Representations on Hanslope Parish Neighbourhood Plan 2016-2031 – Submitted Plan

Technical Note 01:

Transport Appraisal

Job Name: Williams Close, Hanslope

Figure 3 – Possible Site Access

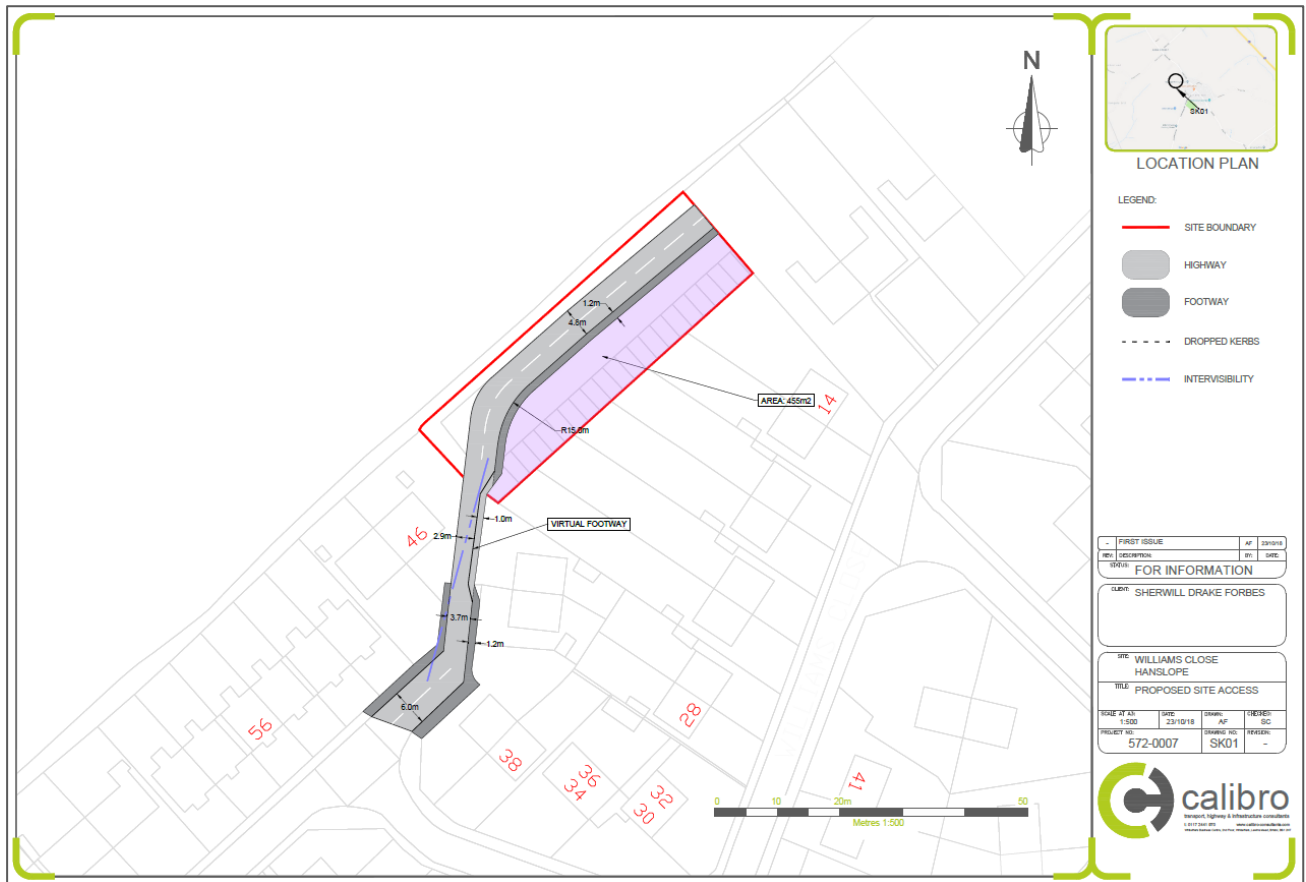
The existing site has the benefit of vehicular access via a narrow, metalled surface road of 3.7-metres wide which is substandard for two-way traffic movements and would therefore normally need to be upgraded. However, review of the Local Authority online mapping system (refer below) suggests that the access road is unadopted and privately maintained, with adjoining properties in separate control. Consequently, there is limited potential to widen.

Notwithstanding, the fact that localised widening would be desirable, an alternative strategy of informal shuttle working through the narrow section with widening at either end to allow vehicles to wait and pass could be utilised in this location given the available indivisibility.

Allied with this, there would be a need to integrate with the surrounding pedestrian networks and in this respect, there would be a need to incorporate a “virtual footway” within the carriageway of the narrow section of the road to provide a delineated pedestrian walk-way which would also be overrun able for larger vehicles. The opportunity to provide a virtual footway is limited to circa 1-metre to ensure the safety of pedestrians. However, this remains unsuitable for two-way pedestrian traffic and the consequence could be to push pedestrians into the carriageway in conflict with vehicle traffic.

Taking these proposals together, the following access strategy could be utilised, which is shown in Figure 3 below, and included to scale at [Appendix A](#).

Figure 4 – Refuse Collection Viability

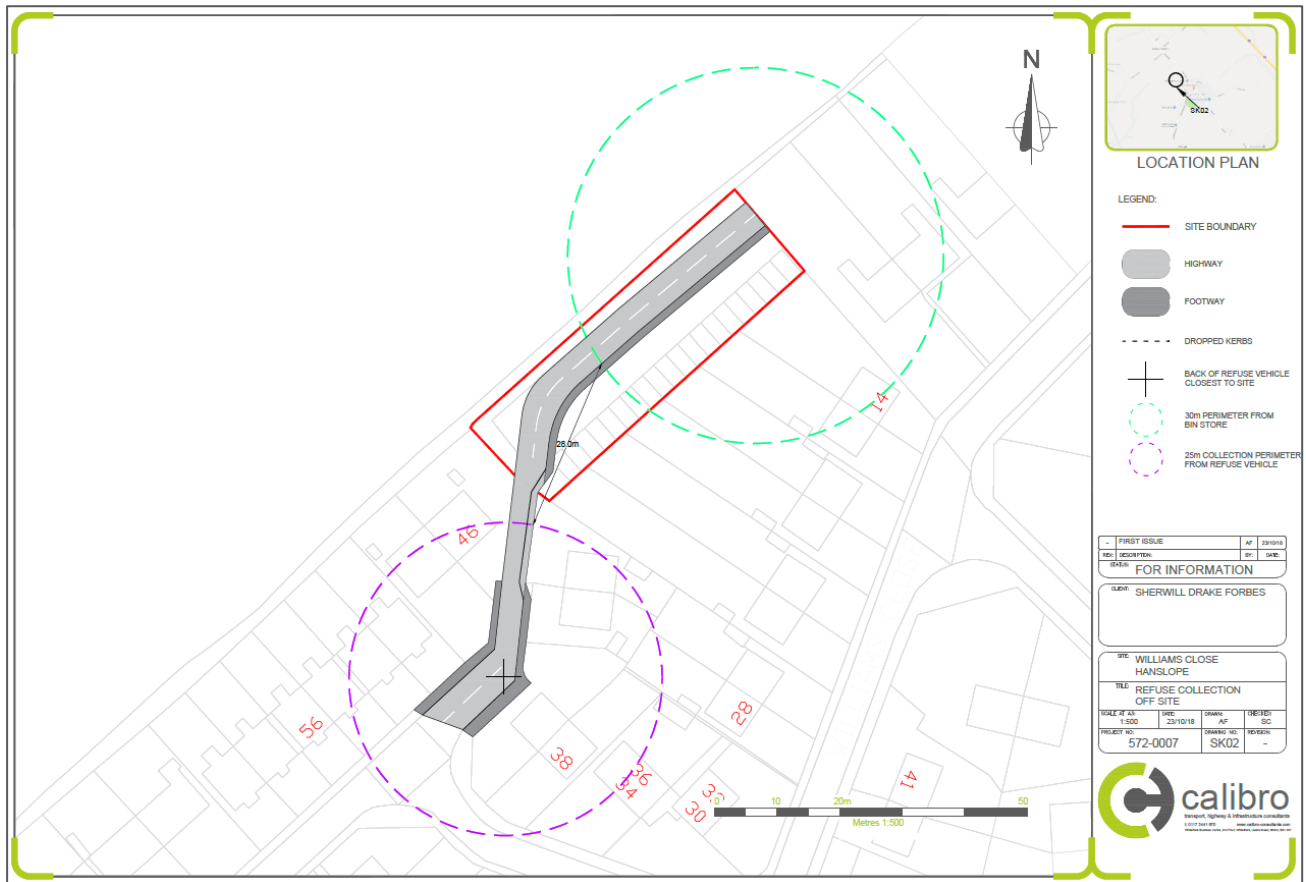
In addition to resident access, there is a need to provide a suitable refuse collection strategy. In this respect, Manual for Streets guidance suggests that residents should not have to carry waste more than 30-metres to a storage point and waste collection vehicles should be able to get to within 25-metres of the storage point.

An assessment of these distances has been undertaken from the limit of the adopted highway and the furthest point of the site, reflecting the potential location of the furthest dwelling. The results are shown in the figure below, which is included to scale at [Appendix B](#).

The above figure demonstrates that it would not be possible to provide a refuse storage point within appropriate distance of all of the bungalows and it would therefore be necessary for a refuse vehicle to enter the site to service the dwellings.

Figure 5 – Refuse Collection On-Site

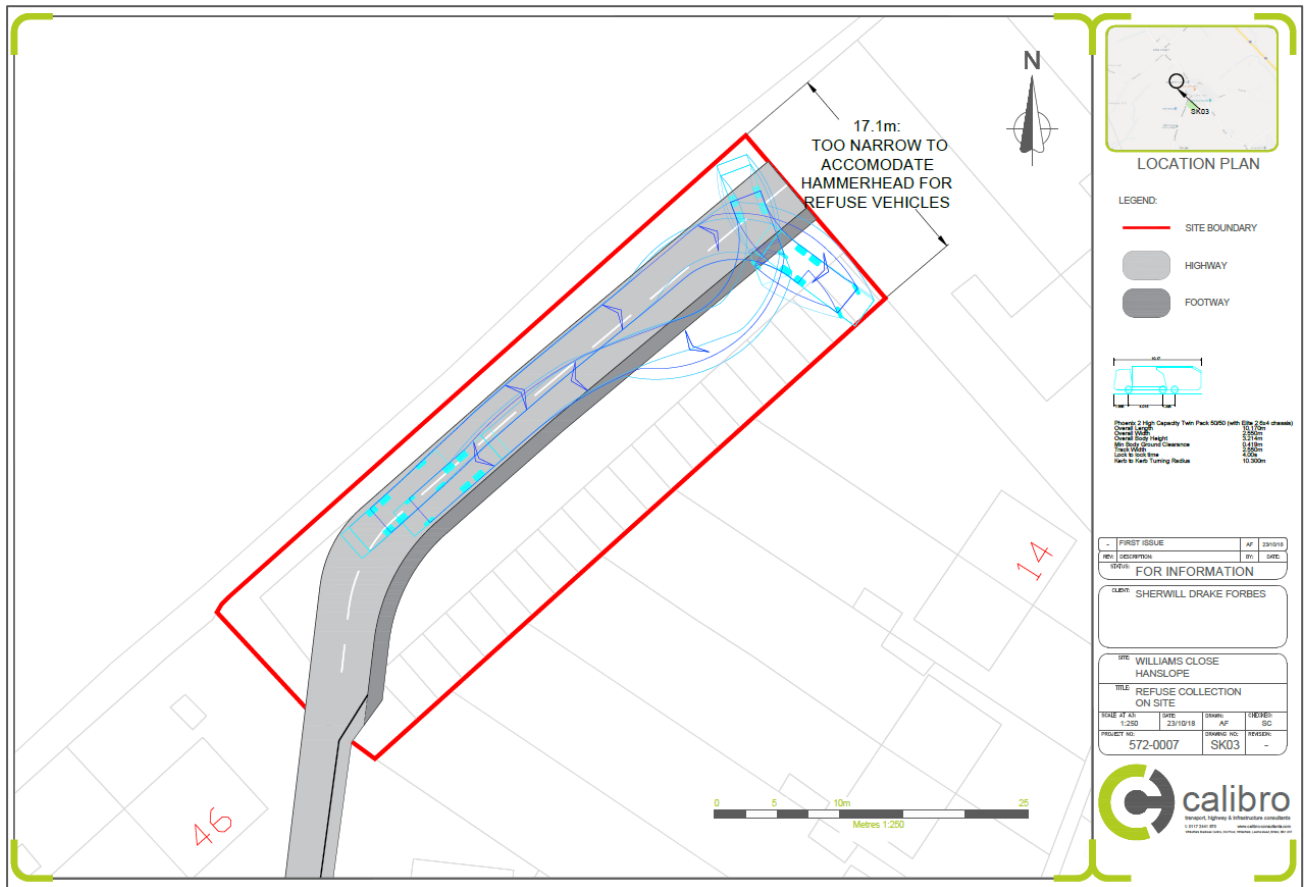
In order to facilitate an on-site refuse strategy, a turning-head would need to be provided within the site to accommodate the requisite turning manoeuvres. The figure below, which is included to scale at [Appendix C](#), shows the swept-path analysis of a refuse vehicle executing a turning manoeuvre within the site.

The figure above demonstrates that the width of the site is too narrow to allow a refuse vehicle to turn within the site. Even if this manoeuvre could be accommodated within the site, the turning-head required to accommodate it would occupy a significant amount of space and further constrain the delivery of the development.

Figure 7 – PIA Accident Data

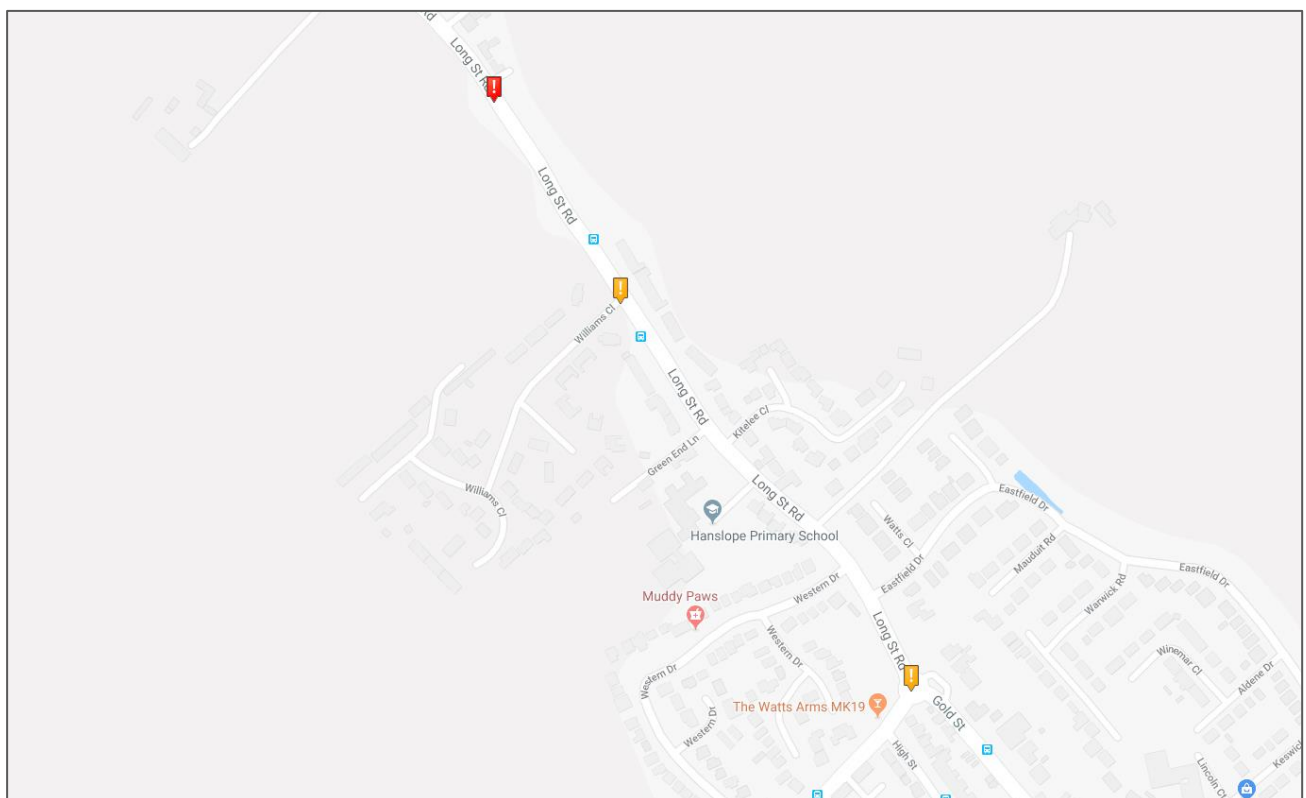
Road safety data has been obtained via the public database available at crashmap.co.uk for the most recent five-year period available: 2013 to 2017 inclusive. Within the vicinity of the site, no personal injury accidents (PIAs) have occurred during the most recent five-year period available. The study area comprises Williams Close and Long Street Road within the vicinity of the site, as illustrated on the figure below.

The data demonstrates that whilst an accident which involved three vehicles resulted in two seriously injured casualties, there is there are no accident clusters or hotspots within the study area during the most recent 5-year period.

TITLE: REFUSE COLLECTION
ON SITE

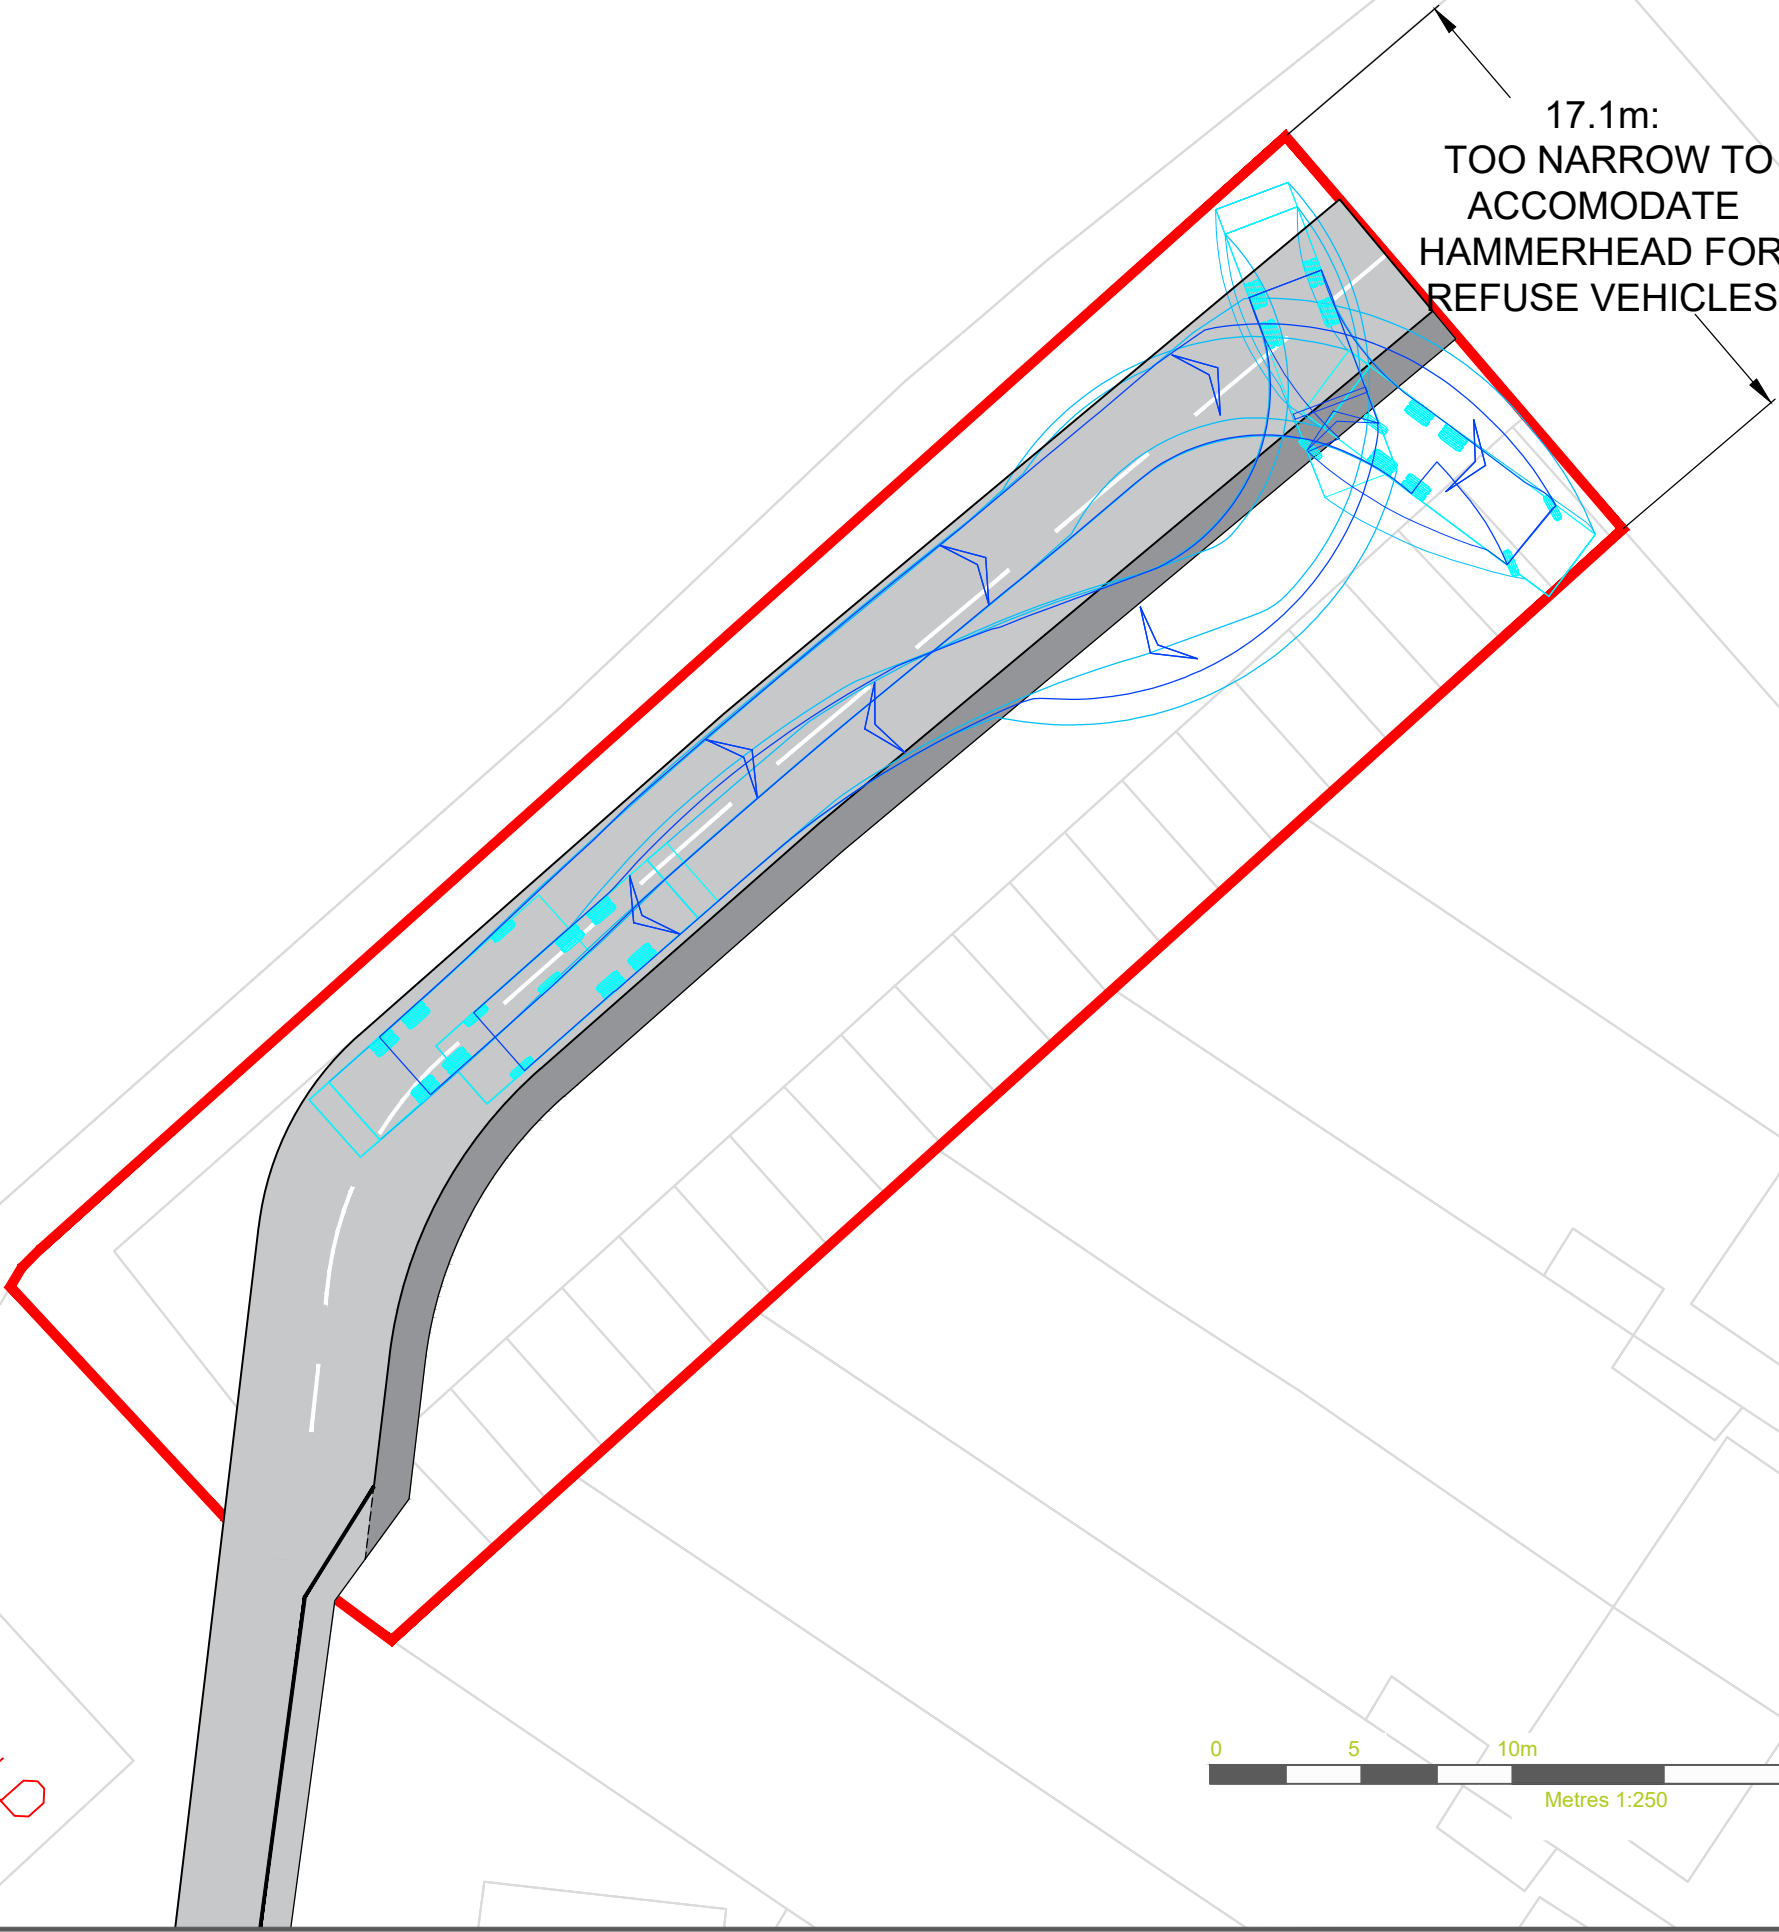
17.1m:
TOO NARROW TO
ACCOMODATE
HAMMERHEAD
FOR
REFUSE VEHICLES
